Broadcast Products Technical Bulletin 20-2009-047

SUBJECT: **MANUAL CORRECTION—CONNECTION CABLE FOR DK-TECHNOLOGIES PM 5639/06 PROBE**

MODEL: **BVM-L230**

Figure 1

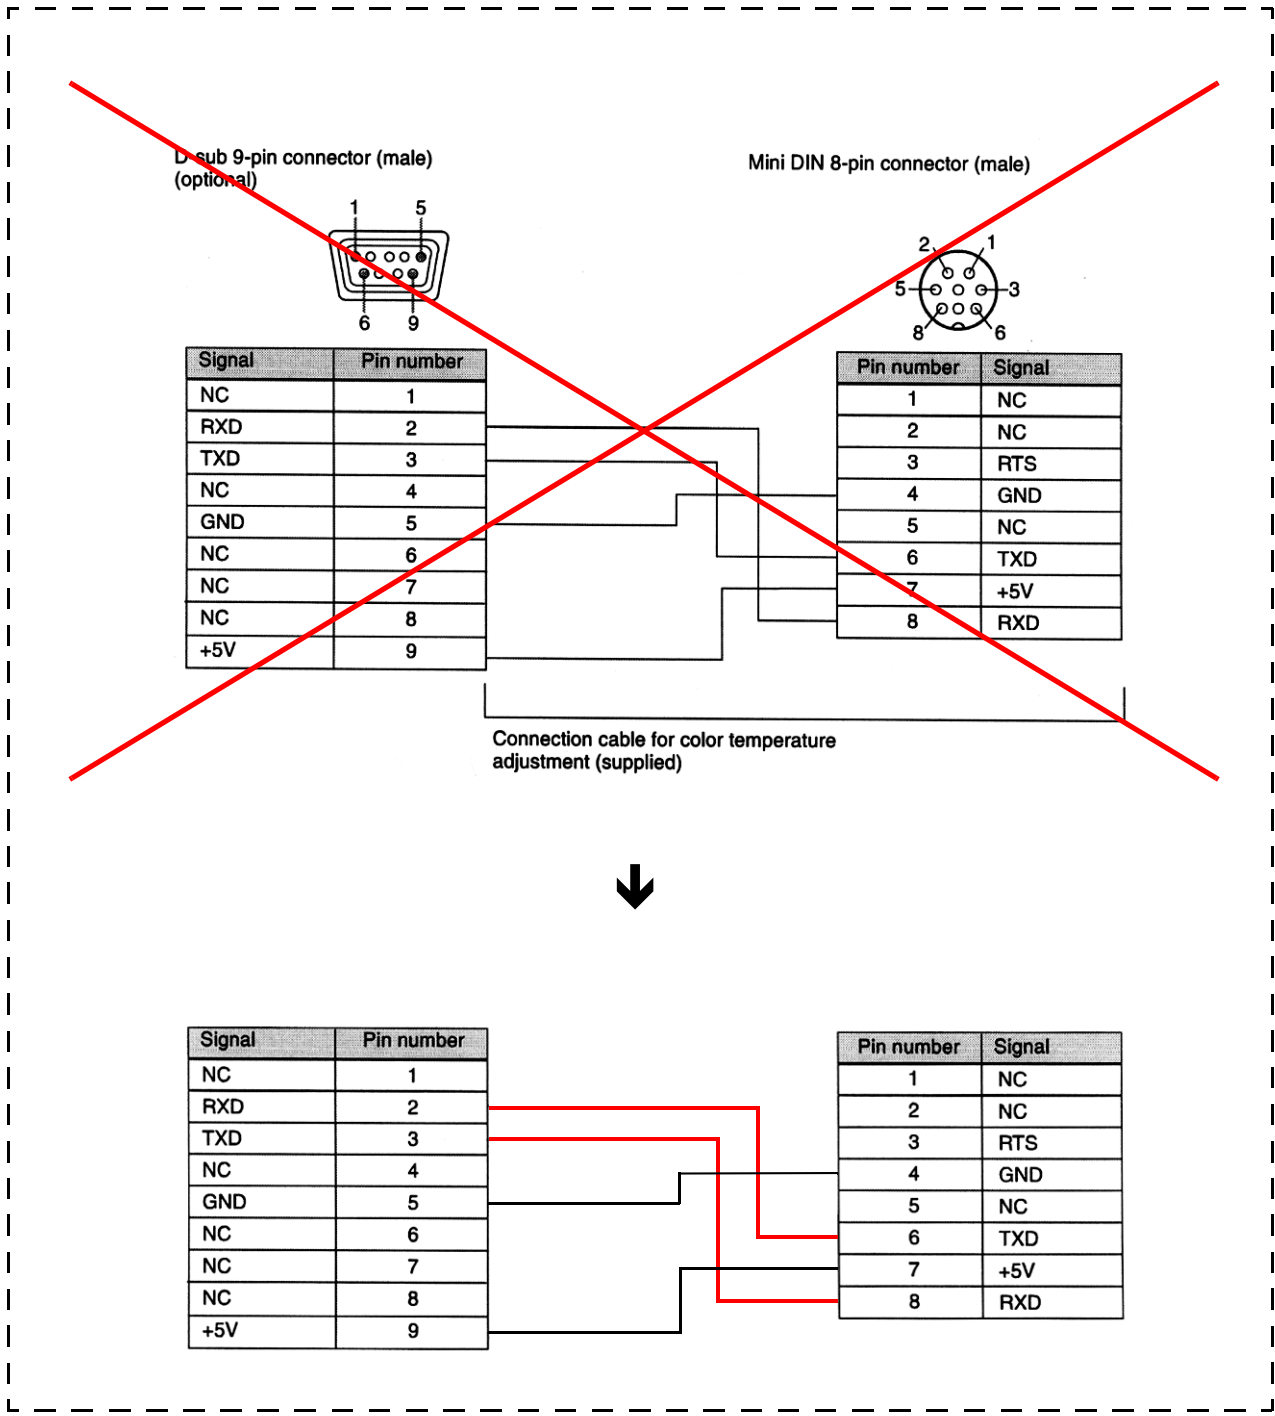
Correct the following manual as shown in Figure 1.

The wiring of RXD and TXD is corrected in the manual as follows:
